UNITED STATES PATENT AND TRADEMARK OFFICE

Office Action Summary	Application No. 10/724,821	Applicant(s) BOURLA, DAN	
	Examiner Brandi N. Thomas	Art Unit 2873

DETAILED ACTION***Claim Rejections - 35 USC § 102***

FIG. 7

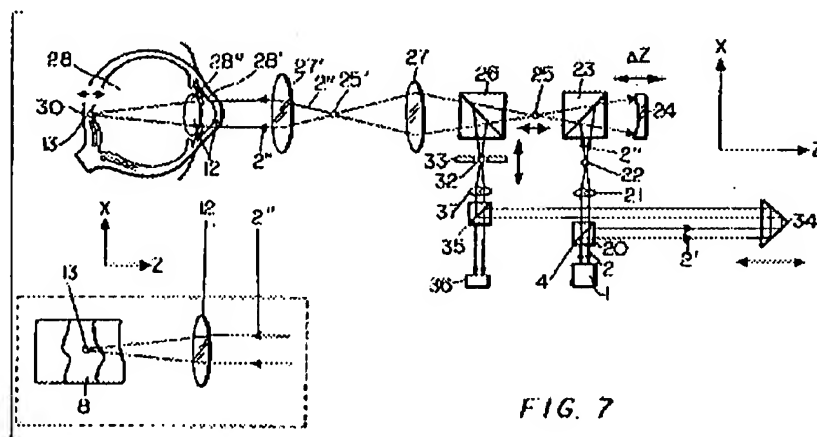
Regarding claim 7, Fercher discloses, in figures 1 and 7, a method for performing biometry, comprising: removing a lens from an eye; and making biometric measurements with a partial coherence interferometry (PCI) device aimed at the eye (30) after removal of the lens therefrom (col.9, lines 51-59).

Regarding claim 8, Fercher discloses, in figures 1 and 7, a method for performing biometry, further comprising calculating optical features based on the biometric measurements

Regarding claim 9, Fercher discloses, in figures 1 and 7, a method for performing biometry, further comprising making biometric measurements with the PCI device aimed at the eye (30) after insertion of an IOL (12) into the eye (30) (col. 10, lines 5-10).

Regarding claim 10, Fercher discloses, in figures 1 and 7, a method for performing biometry, further comprising making pre-incision biometric measurements with the PCI device (col. 9, lines 50-54).

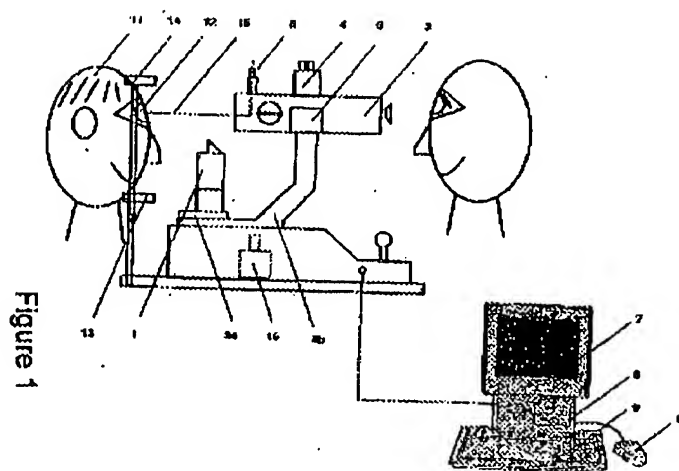
Regarding claim 11, Fercher discloses, in figures 1 and 7, a method for performing biometry but does not specifically disclose using said microscope to focus radiation from the PCI device to the eye. Baumann et al. discloses using said microscope (2) to focus radiation from the PCI device to the eye (12) (section 0017). Therefore it would have been obvious to one having ordinary skill in the art at the time the invention was made to combine the device of Fercher with the microscope of Baumann et al. for the purpose of using the microscope as an observation system (section 0017).

Regarding claim 12, Fercher discloses, in figures 1 and 7, a method for performing biometry, wherein said PCI device comprises an interferometer that directs a beam to a beam splitter (37), and the method further comprises using said beam splitter (37) to direct a portion of radiation incident thereon towards a lens (37) (col. 9, lines 59-62) but does not specifically disclose the use of a microscope. Baumann et al. discloses using said microscope (2) to focus radiation from the PCI device to the eye (12) (section 0017). Therefore it would have been obvious to one having ordinary skill in the art at the time the invention was made to combine the device of Fercher with the microscope of Baumann et al. for the purpose of using the microscope as an observation system (section 0017).

Regarding claim 13, Fercher discloses, in figures 1 and 7, a method for performing biometry, wherein said PCI device further comprises a lens system, and the method further comprises using said lens (12) to focus radiation incident thereon to a portion of the eye (30) to generate a secondary radiation source on the portion of the eye (30) (col. 10, lines 5-8), wherein radiation emanating from the secondary radiation source passes through said beam splitter (37) and impinges upon said lens system (col. 12, lines 11-24) but does not specifically disclose the

Regarding claim 14, Fercher discloses, in figures 1 and 7, a method for performing biometry, further comprising using at least one photodetector (36) to detect radiation exiting said lens system (col. 9, lines 51-54).

Regarding claim 15, Fercher discloses, in figures 1 and 7, a method for performing biometry, further comprising processing an output from said at least one photodetector (36) (col. 9, lines 51-54).

Regarding claim 16, Fercher discloses, in figures 1 and 7, a method for performing biometry, a difference between path lengths of radiation traversing arms of the interferometer equals the product of the length and refractive index of a reference eye (30) (col. 12, lines 24-30) but does not specifically disclose wherein said interferometer comprises a Michelson interferometer. It would have been obvious to modify the invention to include a Michelson interferometer, since it has been held to be within the general skill of a worker in the art to select a known material on the basis of its suitability for the intended use (In re Leshin, 125 USPQ 416). Therefore it would have been obvious to one having ordinary skill in the art at the time the invention was made to modify the invention to include a Michelson interferometer for the purpose of its ability to allow light strikes a partially reflecting plate at an angle of 45° , the light beams reflected and transmitted by the plate are both reflected back to the plate by mirrors.
